**Joint Meeting of Village Board of Trustees and Plan Commission – Agenda
Thursday, August 15, 2024
Village Hall, 65 Cedar Avenue**

RE: Conceptual Review #2 for Cedar Lake Park Planned Development

<u>Property Owner</u>	<u>Property Location</u>	<u>Zoning District</u>
Rick Murphy, Lennar 1700 E. Golf Road Suite 1100 Schaumburg, IL 60173	Cedar Lake Park (Southeast corner of Grand Avenue and Cedar Lake Road)	UR3A – Urban Residential
<u>Petitioner and/or Contract Purchaser:</u>	Lennar c/o Rick Murphy 1700 E. Golf Road Schaumburg, IL 60173	
<u>Representatives:</u>	Rick Murphy	
<u>Site Location:</u>	Cedar Lake Park	
<u>Requested Action</u>	Plan Commission to review and discuss proposed Site Plan and Conceptual Drawings

CONCEPT PLAN
LAKE VILLA, ILLINOIS

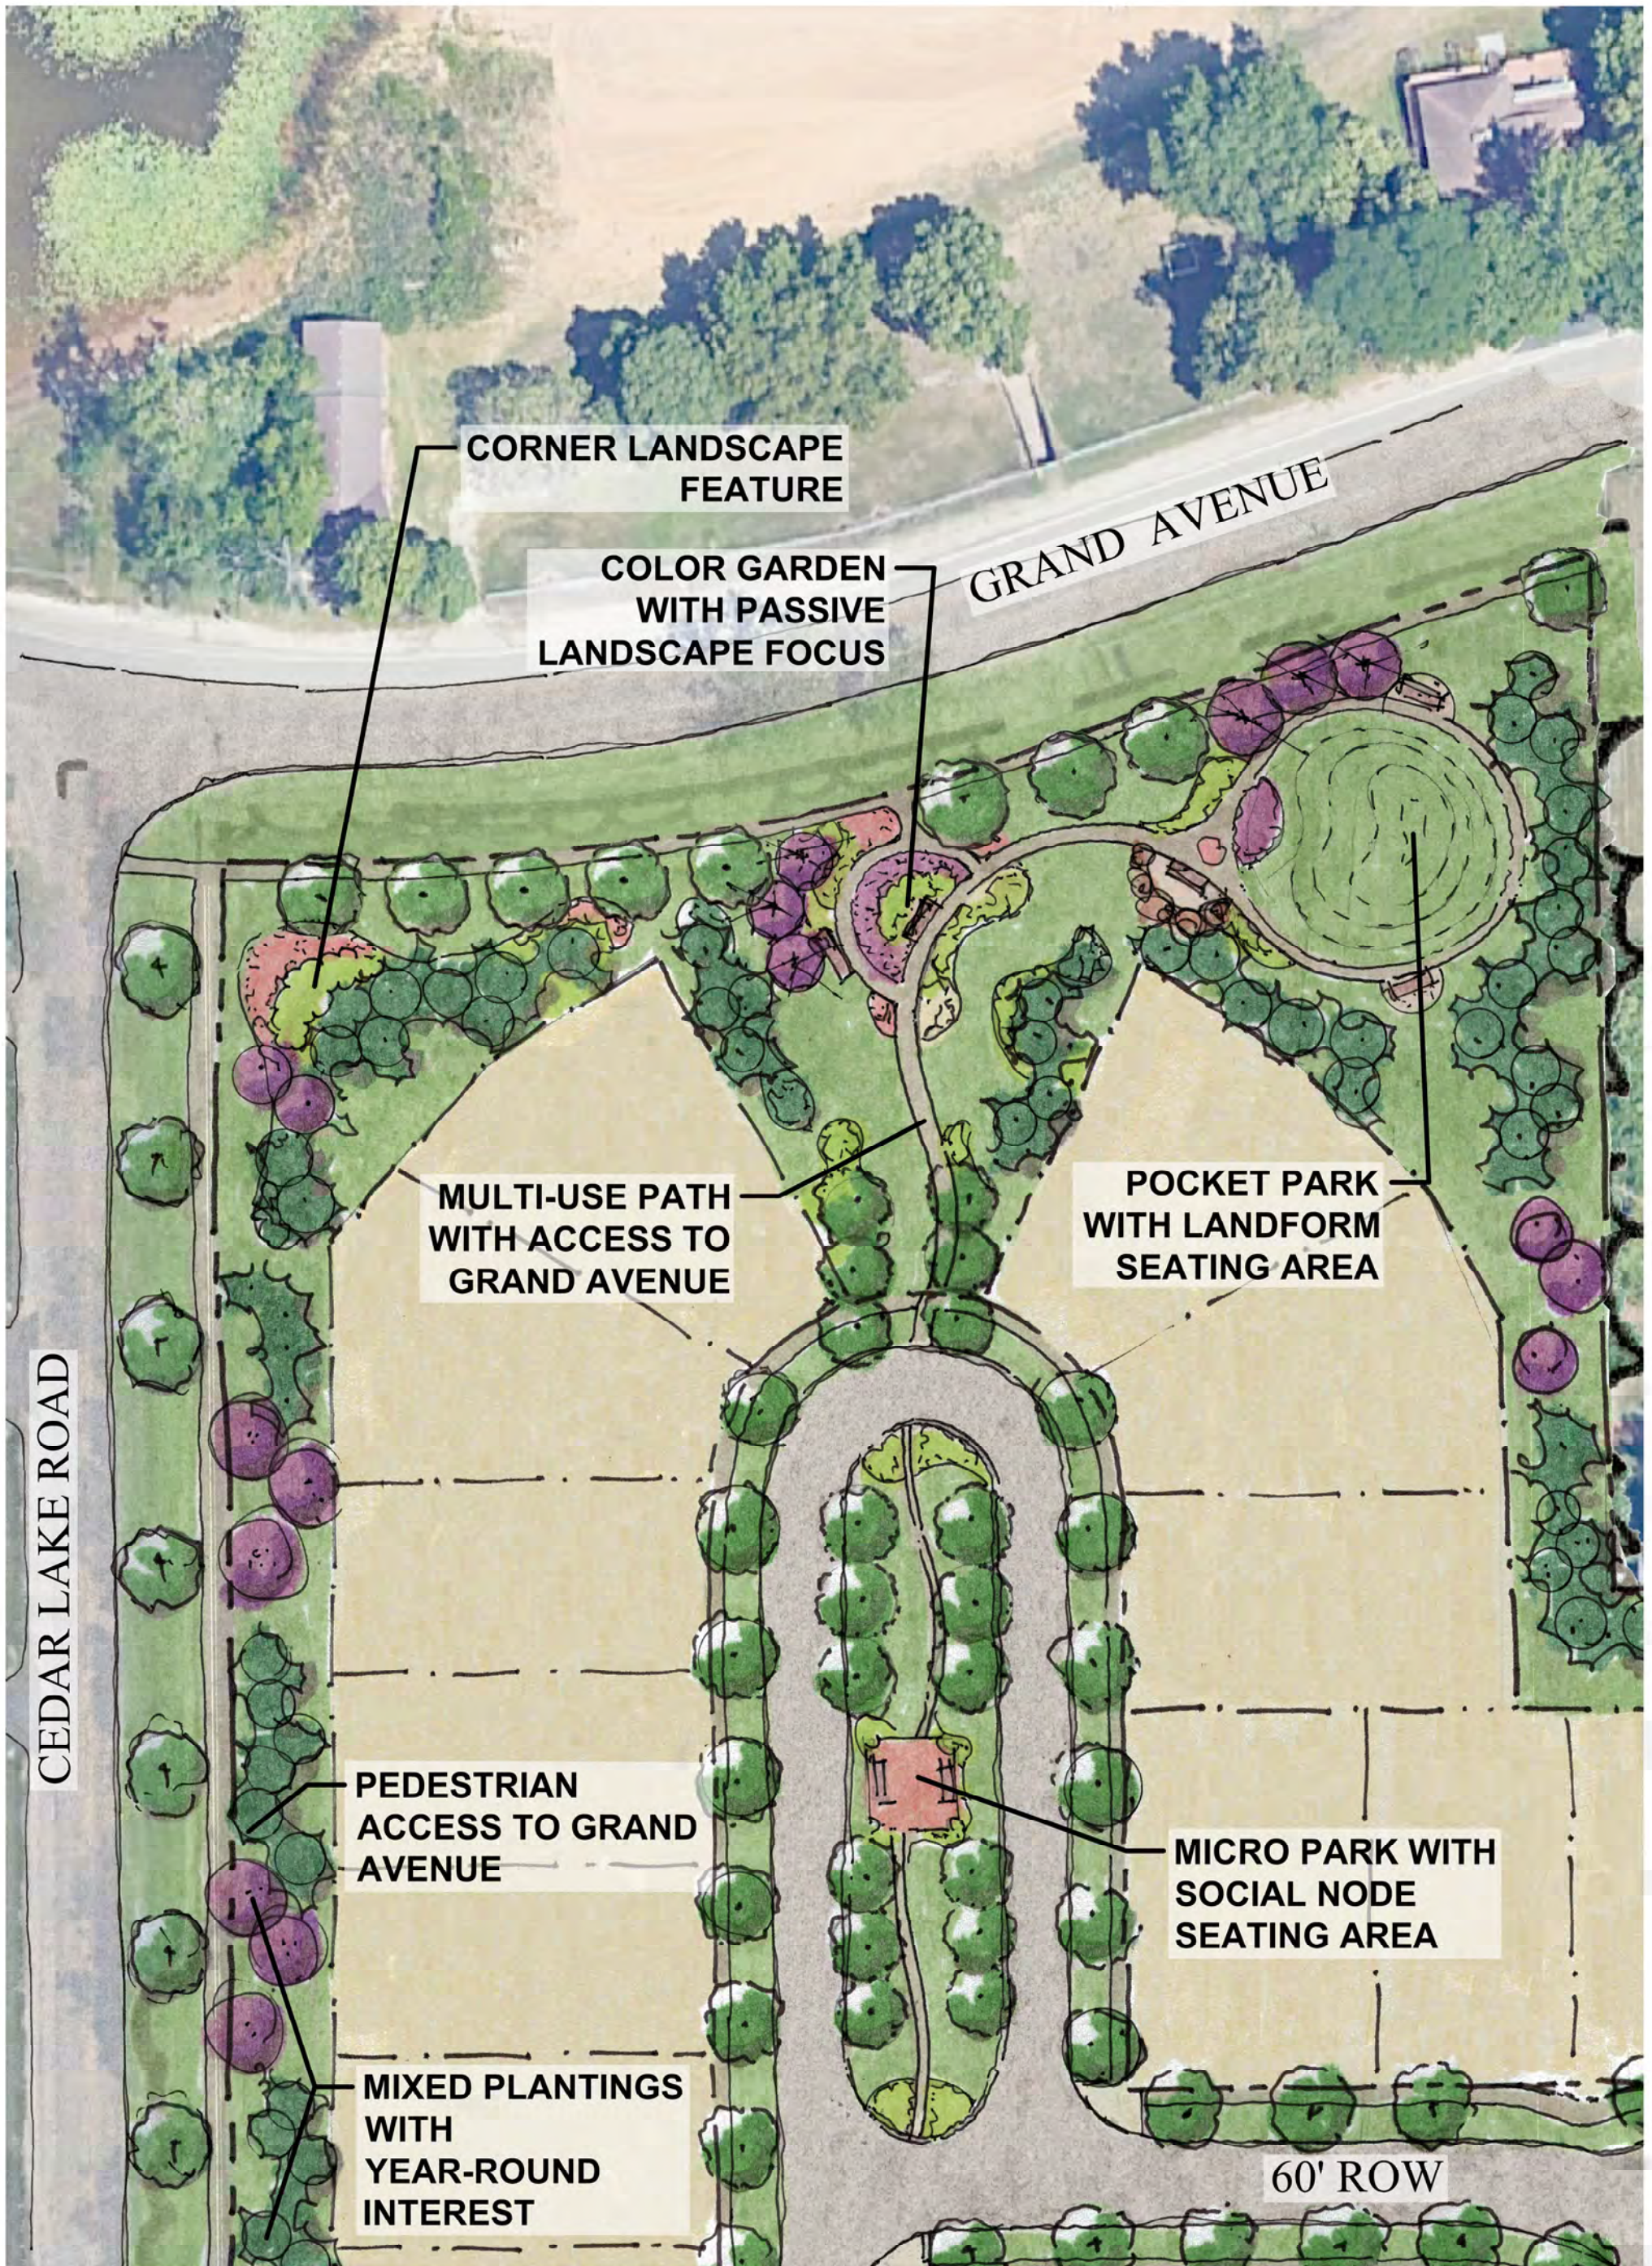
In evaluating the site plan, it appears that the lot mixes required under the UR3A Zoning District have been met; however, the Developer is proposing to distribute the lot mixes across the entire subdivision rather than distribute them on a consistent basis.

In reviewing the concept plan, staff is requesting the PCZBA to consider the following observations relative to the revised site plan:

- Are the use(s) proposed in the Site Plan consistent with the intent of the UR3A zoning district classification?
- Is it appropriate for the lot sizes to be dispersed per the UR3A zoning district requirement or be distributed consistently as the UR3A zoning district requires?
- The proposed single-family dwelling units meet the minimum livable area in the UR3A Zoning District, which require that units be a minimum of 1,800 square feet for single-story and 2,100

square feet for two-story units. The Plan Commission may want to review the Developer's anti-monotony guidelines to ensure that the Village's architectural standards are adhered to;

- The Site Plan includes a "pocket park" amenity that includes a substantial public benefit which was not proposed in the original Cedar Lake Park concept plan, does the revision on the plan for the additional pocket park on Grand Avenue address the PCZBA's concern with walkability to the downtown area?

- The Site Plan offers trail (bike path) connectivity to the Public Works facility south of Oakwood Avenue, along with a trail that would connect to the Grant Woods Forest Preserve to the southern extent of the Property. This is a slight deviation from the original plan, in that the proposed trail system was to extend around the periphery of the entire development site (Cedar Lake Road and Grand Avenue). The Plan Commission may want to discuss whether the new concept provides for enough public benefit and whether a sidewalk along Cedar Lake Road, at the potential expense of an existing landscape buffer, is worth the improvement.

- The previous plan received some critiques over the location of the ingress/egress from Cedar Lake Road. In 2007, the Plan Commission suggested that the entryway be moved further south toward the Forest Preserve property to protect the single-family residences along Cedar Lake Road, are there any questions the PCZBA has relative to the location of the access point?

- The previous plan discussed a secondary (or emergency) access to Oakwood Avenue and/or to the Public Works Facility located at the end of Oak Knoll Drive. The Plan Commission may want to discuss whether a secondary public access or emergency access to the site is necessary.
